# Wisconsin Department of Transportation

**Proposal #23: 1133-10-75, WISC 2015 135**  
**DePere - Suamico**  
**Memorial Drive - CTH M**  
**Velp Ave / USH 141 Intchg**  
**USH 41**  
**Brown County**

**1133-10-77, WISC 2015 136**  
**DePere - Suamico**  
**Memorial Drive - CTH M**  
**Memorial Dr-Duck Crk SB/IH43**  
**Intchg**  
**USH 41**  
**Brown County**

This is Addendum No. 2, which provides for the following:

Addendum No. 2  
IDs 1133-10-75 / 77  
Revised Sheet 52  
March 3, 2015

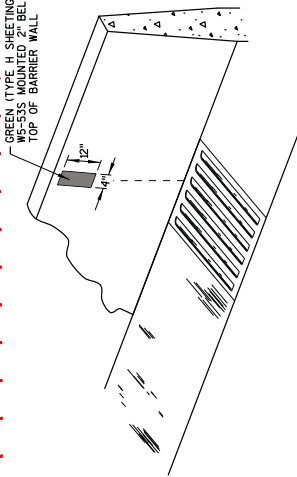
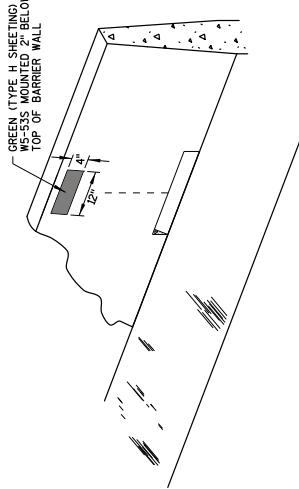
Revised Plan Sheets	
Plan Sheet	Plan Sheet Title (brief description of changes to sheet)
2	General Notes (Update utility contact)
52	Construction Details (Added inlet marking detail)
142	Paving Details (Corrected label)
189	Soil Mitigation Overview (Strip drains removed from plan, installed in previous project)
191	Strip Drain Details (Updated station range)
195	Plan Details: Strip Drains (Strip drains removed from plan, installed in previous project)
200	Plan Details: Strip Drain/Settlement Map (Strip drains removed from plan, installed in previous project)
515	Lighting Plan Legend (Replaced label defining lamp wattage with "LED Type" and specified LED conversions to occur)
552, 554, 556, 558, 560, 562, 564, 566, 568, 570, 572, 574, 576, 578, 580, 582	Lighting Plans (Replace all HPS luminaires with appropriate LED type specified by the provided Luminaire Conversions)
697	Traffic Control Typical Sections – Stage 3 (Updated typicals and added a new one due to staging change along NIH/SIH)

GREEN (TYPE H SHEETING)  
MS-535 MOUNTED 2" BELOW  
TOP OF BARRIER WALL

GREEN (TYPE H SHEETING)  
MS-535 MOUNTED 2" BELOW  
TOP OF BARRIER WALL

Addendum No. 2  
 IDs 1133-10-75 / 77  
 Revised Sheet 552  
 March 3, 2015

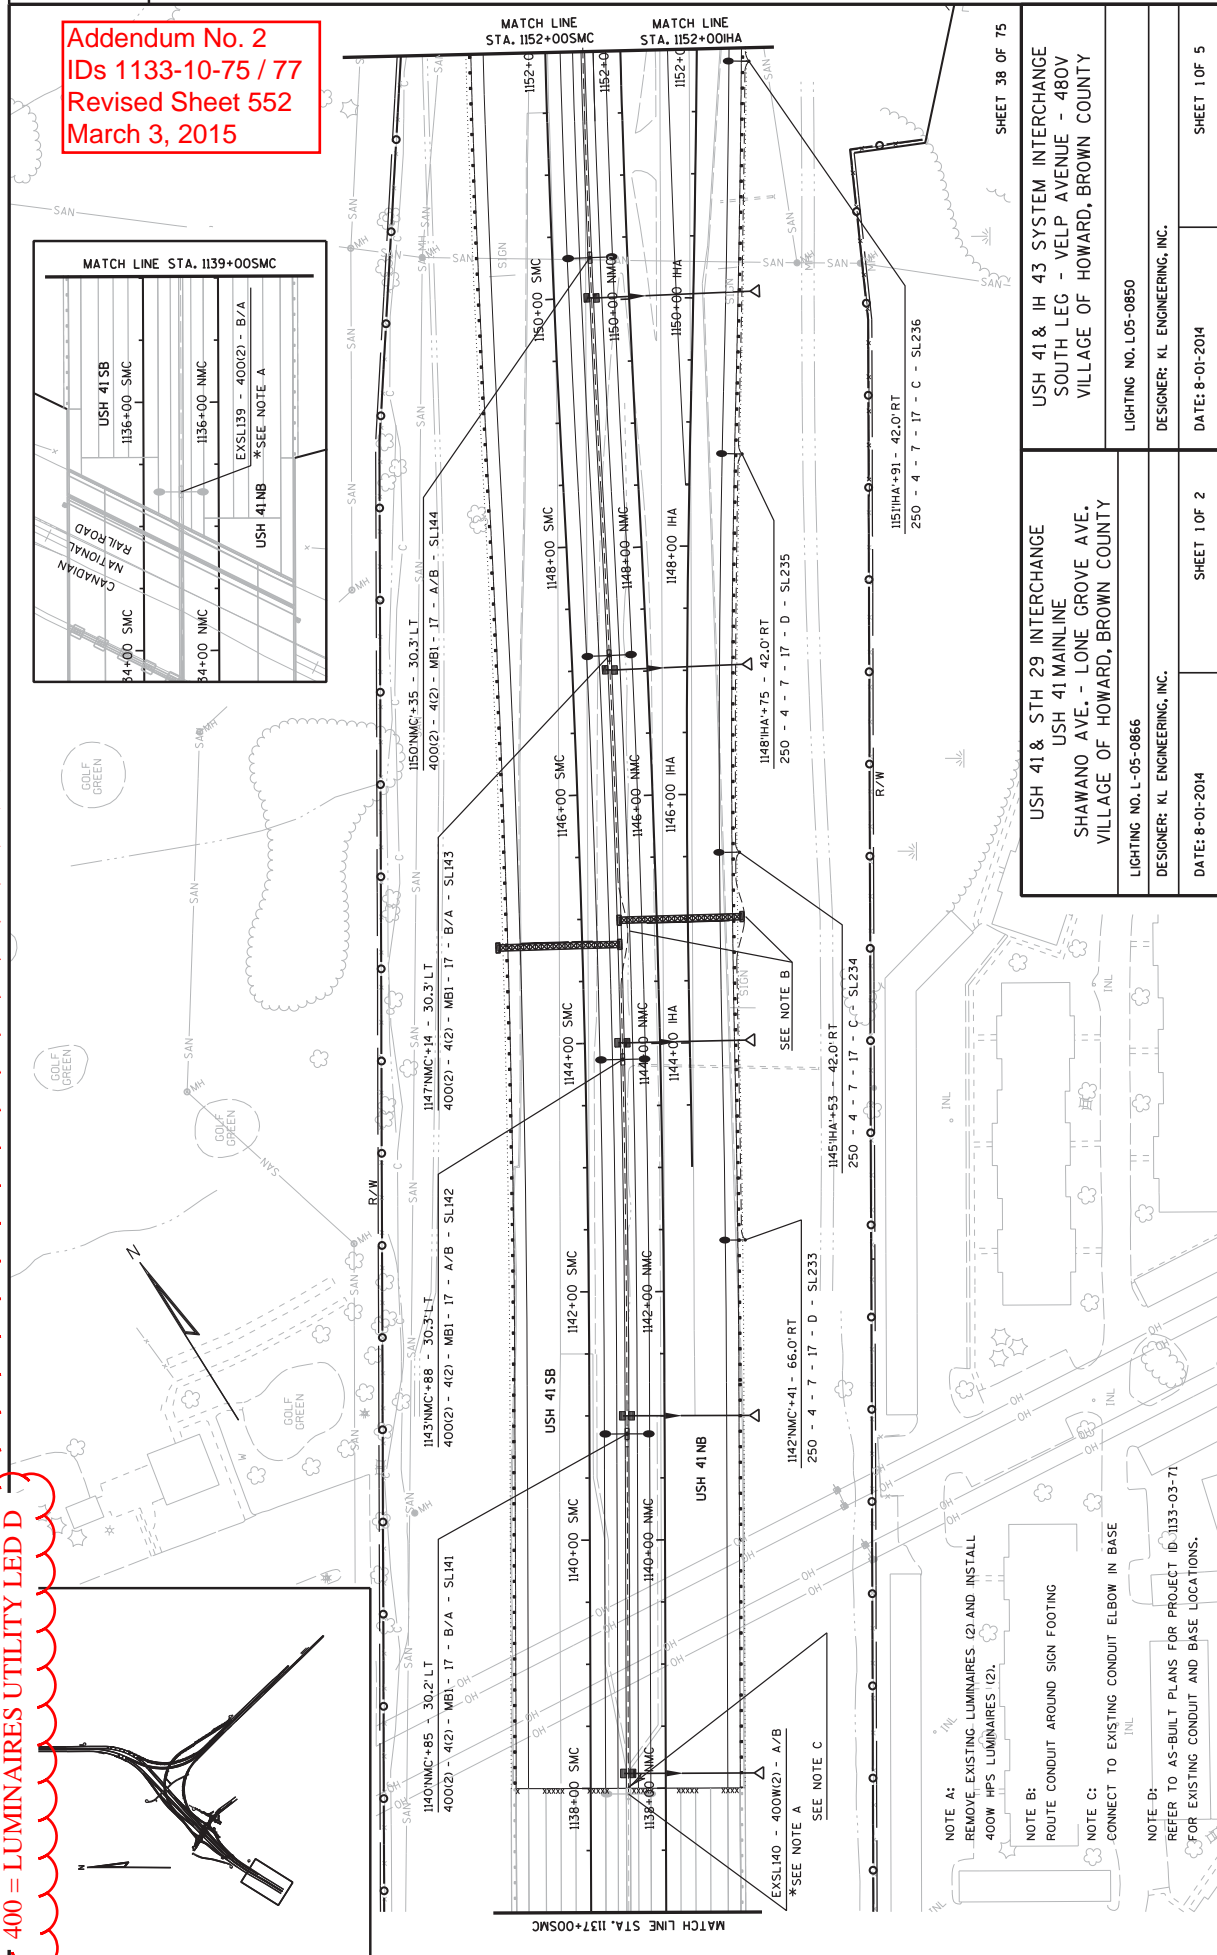
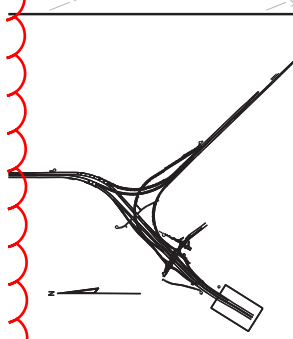
918, 919, 920, 921	Miscellaneous Quantities (Deleted bid items 659.0115, 659.0125, 659.0135; added bid items 659.1115, 659.1125, 659.1130)
936	Miscellaneous Quantities (Updated quantities table due to strip drain removal from plan)
1003	Plan and Profile: Velp Avenue EB – Sidewalk (Update alignment labels)
1008	Plan and Profile: Velp Avenue WB – Sidewalk (Update alignment labels)
1009	Plan and Profile: Velp Avenue WB – Sidewalk (Update alignment labels)
1688	Computer Earthwork Data (Removed quantities due to strip drain removal from plan)
1689	Computer Earthwork Data (Removed quantities due to strip drain removal from plan)

LUMINAIRE CONVERSIONS  
 150 = LUMINAIRE'S UTILITY LED A  
 250 = LUMINAIRE'S UTILITY LED C  
 400 = LUMINAIRE'S UTILITY LED D

Addendum No. 2  
 IDs 1133-10-75 / 77  
 Revised Sheet 554  
 March 3, 2015

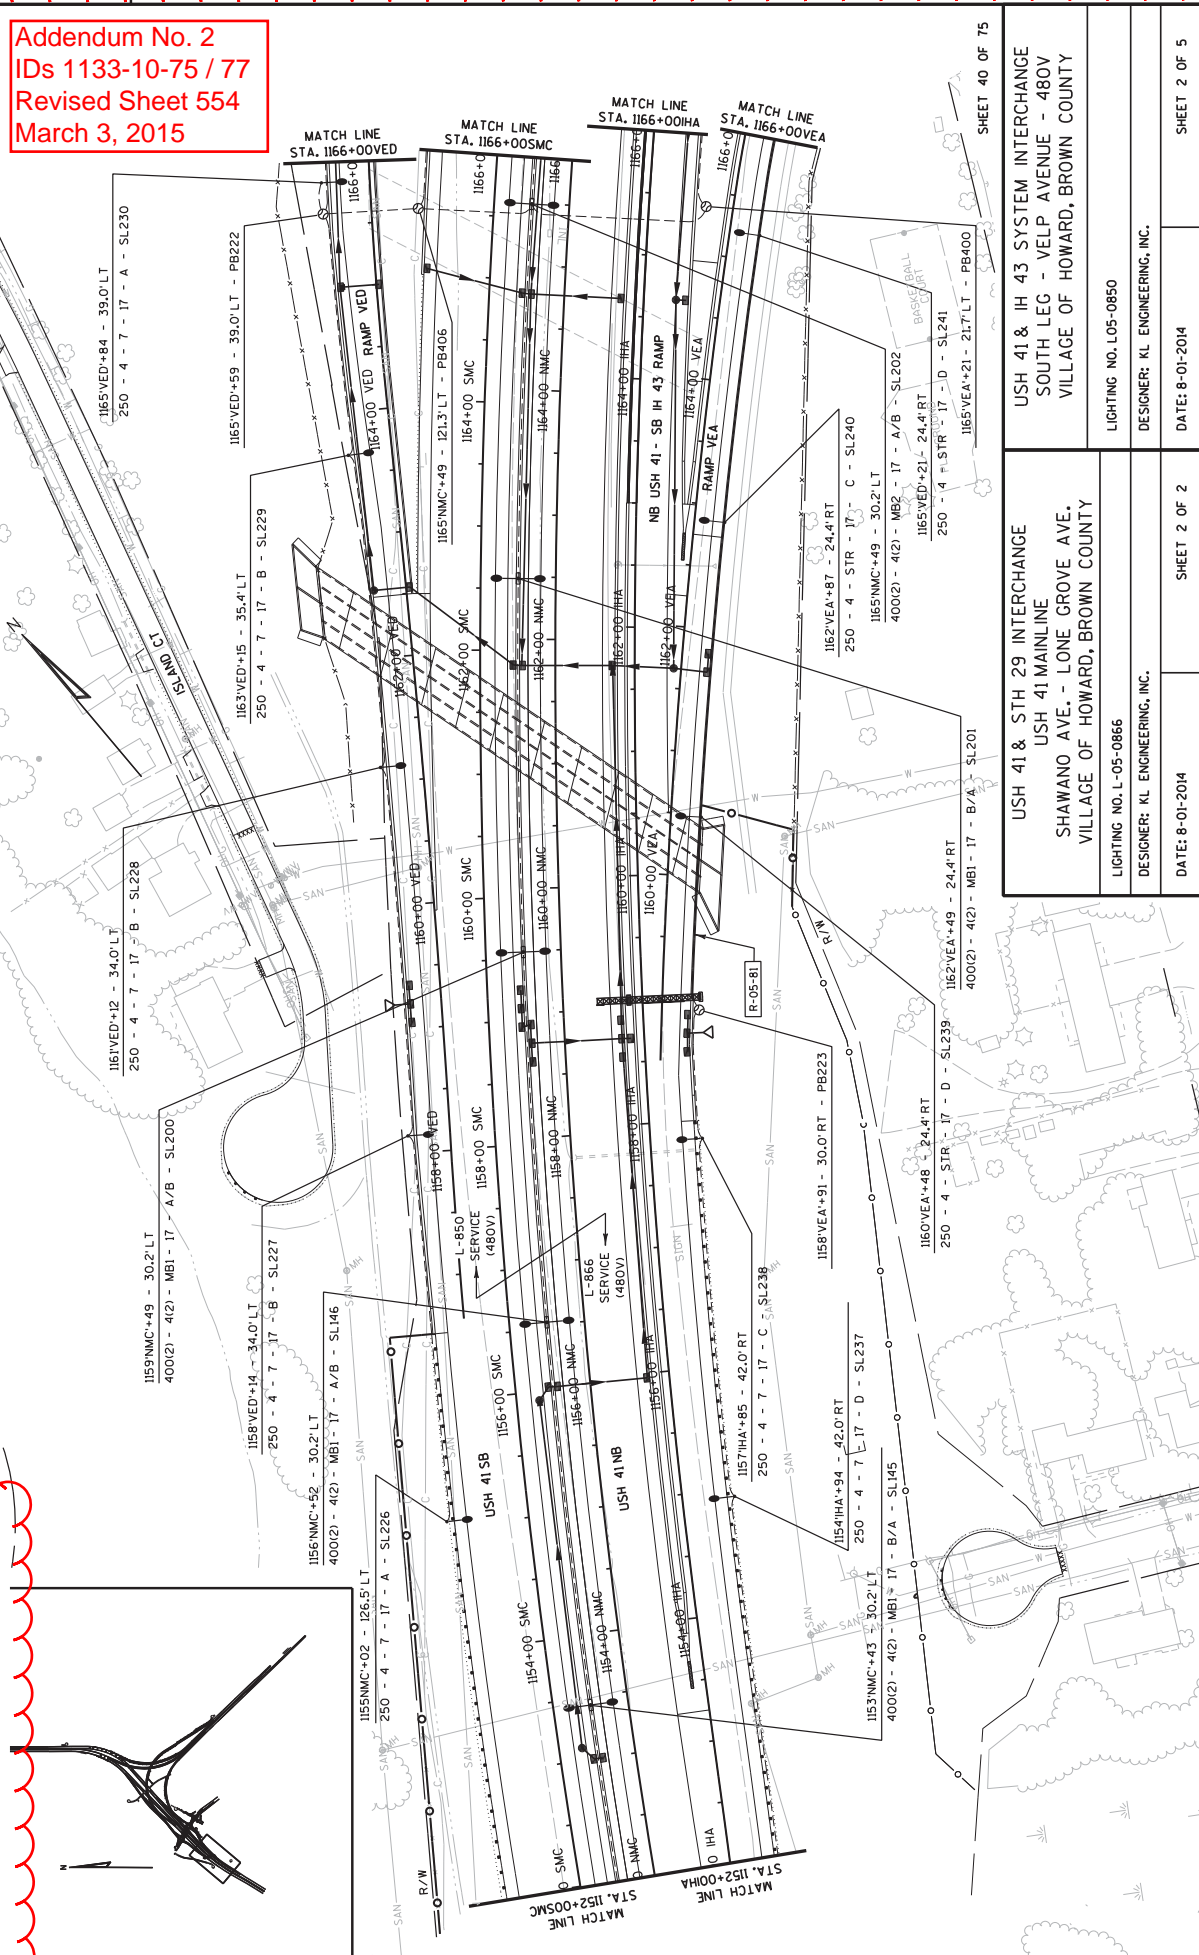
LUMINAIRE CONVERSIONS  
 150 = LUMINAIRES UTILITY LED A  
 250 = LUMINAIRES UTILITY LED C  
 400 = LUMINAIRES UTILITY LED D

**Addendum No. 2**  
**IDs 1133-10-75 / 77**  
**Revised Sheet 760**  
**March 3, 2015**

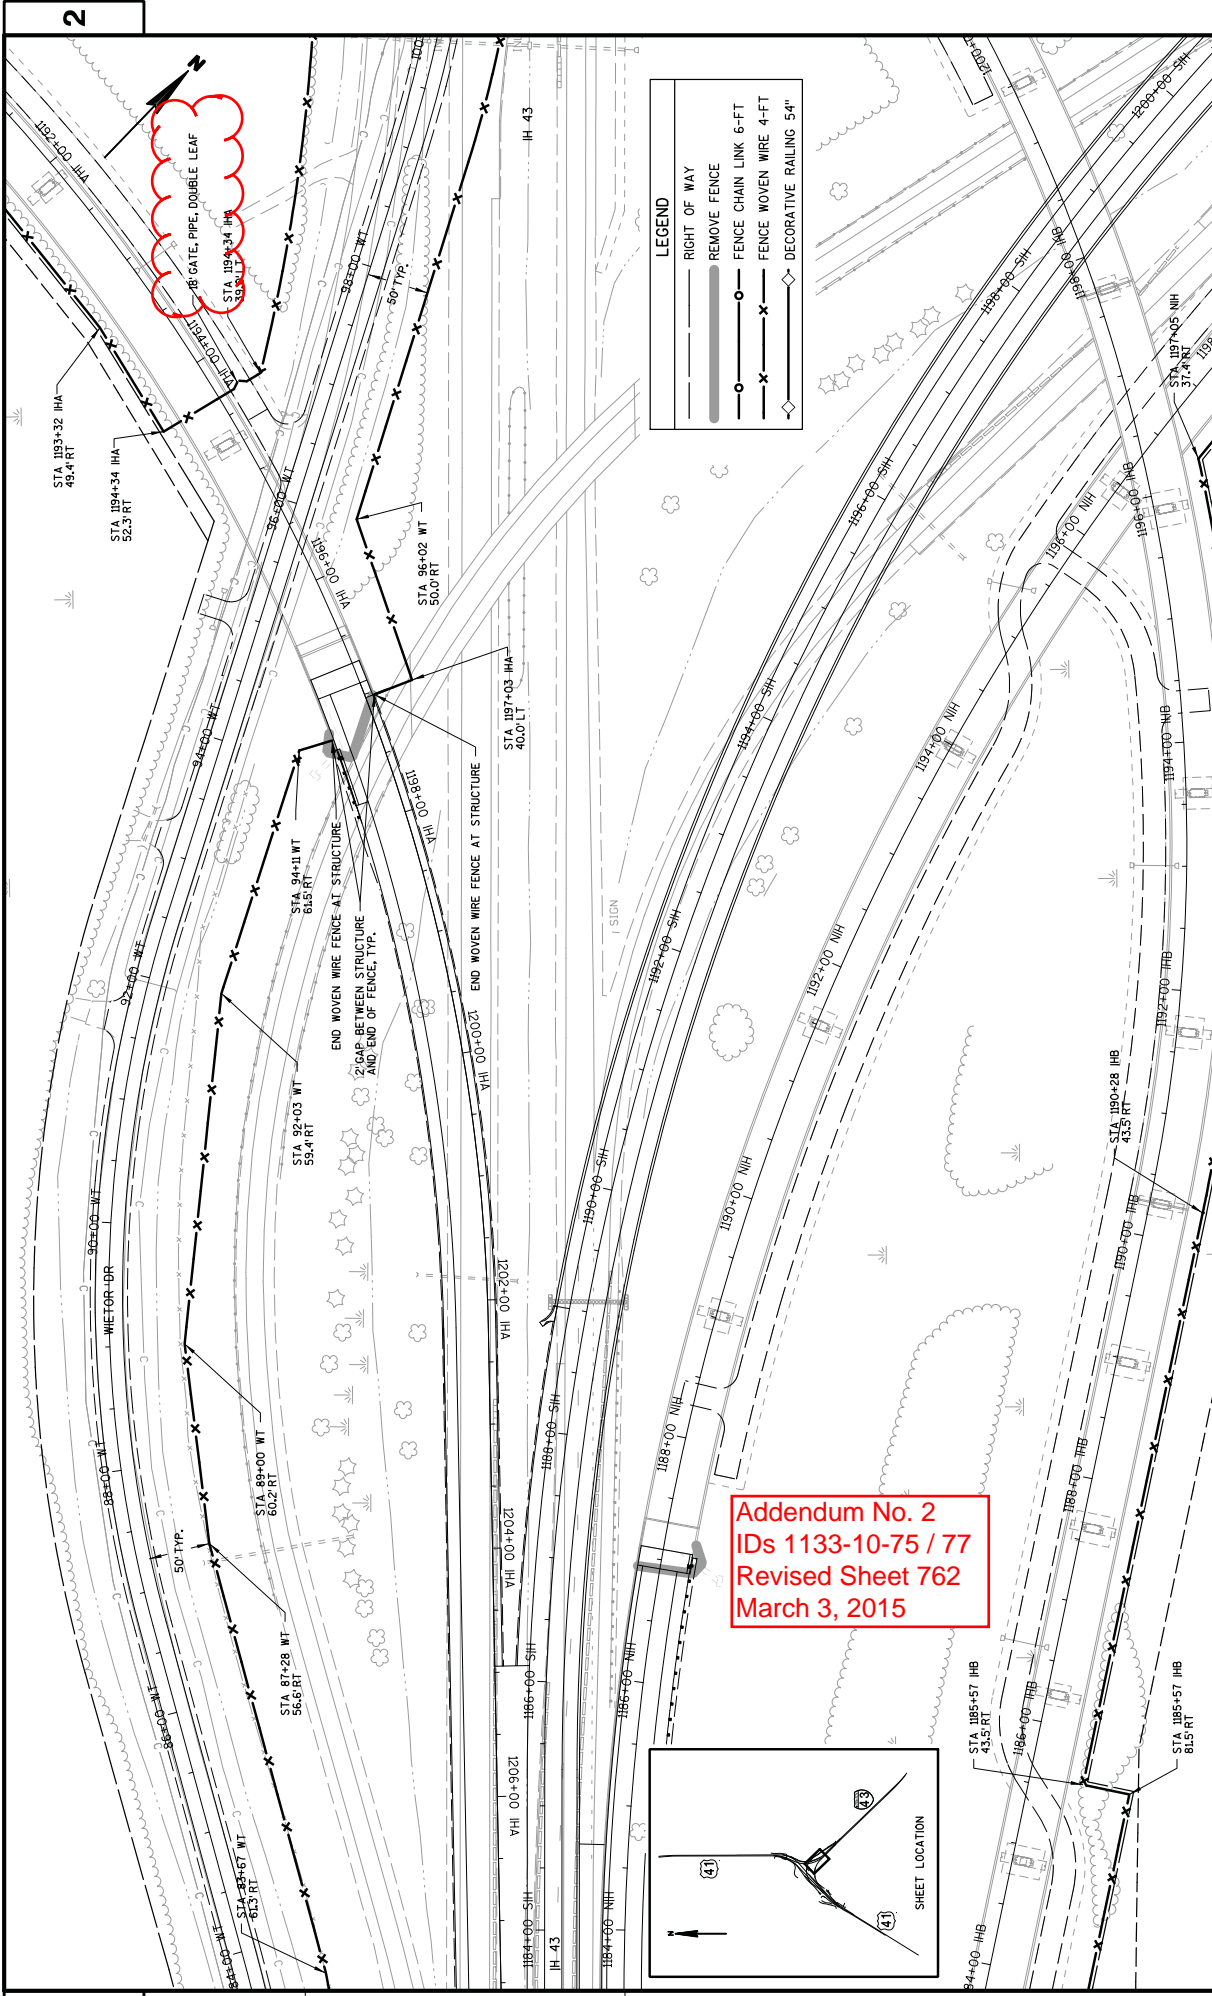
760 - 762	Fencing Plan (Updated gate type)
846	Miscellaneous Quantities (Updated quantities table due to staging change along NIH/SIH)
848	Miscellaneous Quantities (Updated quantities table due to staging change along NIH/SIH)
849	Miscellaneous Quantities (Updated quantities table due to strip drain removal from plan)
869	Miscellaneous Quantities (Deleted bid item 616.0360.S; added bid item SPV.0060.013)
894	Miscellaneous Quantities (Added new bid item SPV.0165.251)
